**DATE:** 12.16.2015

■ **Circle K Convenience Store [TRC Plan Review]**

∞ Initial Review Note ∞

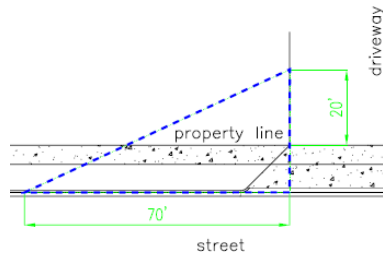
1. The private road off Carolina Beach Road does not appear to meet the requirements for a standard city street. Provide the ROW lines for the street, street cross section, pavement width, horizontal centerline dimensions and other details for a city street. [7-5 CofW Tech Stds]
